Type Coffee Vending Machine	Model FB55 - 7100 Plus - 7100 (ES/FB/IN/B2C) - CV7200/7300 - 7300 - 7600	T.I. NO 12 - 2015		
Serial Number See table included	Subject NEW POSTER Jacobs Douwe Egberts	ISSUED FOR (X)	Action Information	X

A new brand has been defined for all the Douwe Egberts markets, so a new Poster has been introduced. Below a picture of the **old** “Poster Frame” made by a **single graphic panel**.

Poster Frame - Current situation ONLY for The Netherlands
This picture refers to a Gallery 220

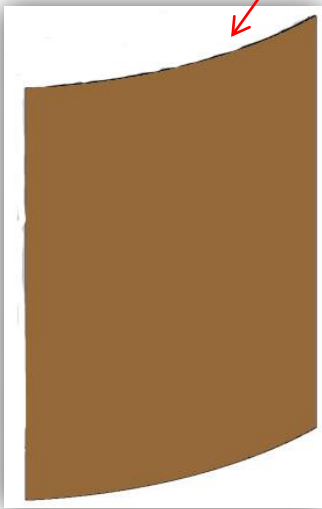
Poster JDE:
single graphic panel
Old graphic

The **new** Poster “**Black background and smoke JDE**” is no longer a single graphic panel, but it’s a **sandwich made of two pieces**, directly mounted in the door of the machines above mentioned.

The poster material is different from the previous one, because the old poster (PVC treated) was in direct contact with the final user in front of the machine.

Poster Frame - New situation
 This picture refers to a CFT 2100

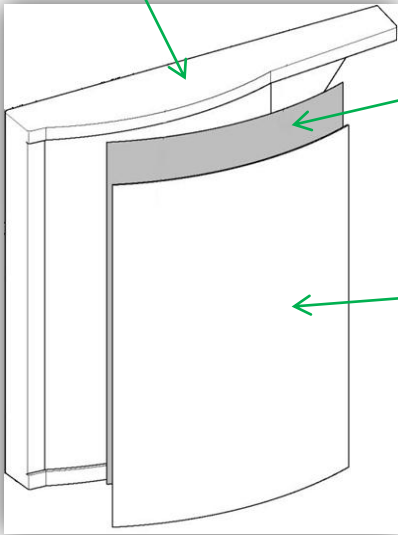
New “**Poster Frame Assembly**”: Poster Frame + a Sandwich made by:
 - Poster Standard JDE (**new graphic**)
 - Poster Panel Glass (**new material**)

Poster Standard JDE
New graphic

Poster Panel Glass
New material

Gallery 110

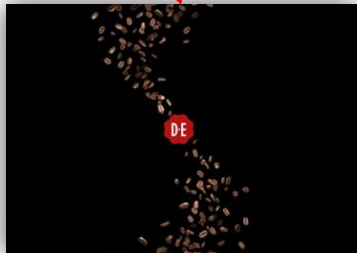
➤ For machine as Gallery 110 and Gallery 420 the poster material is the same, has changed only the brand layout machine (see below in the table the details in term of codes and version).

New Poster JDE
 Single graphic panel:
new graphic

Single graphic panel:
old graphic

Gallery 420

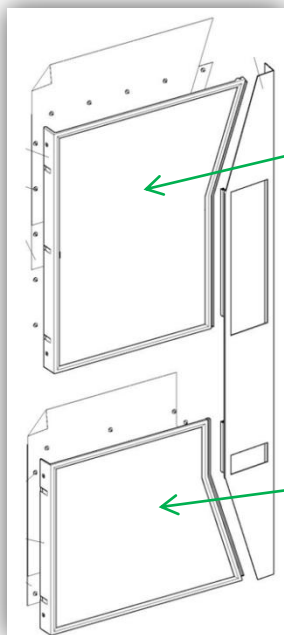
New poster black smoke upper part: new graphic panel (new spare code)

Poster black smoke lower part: the spare code is not changed
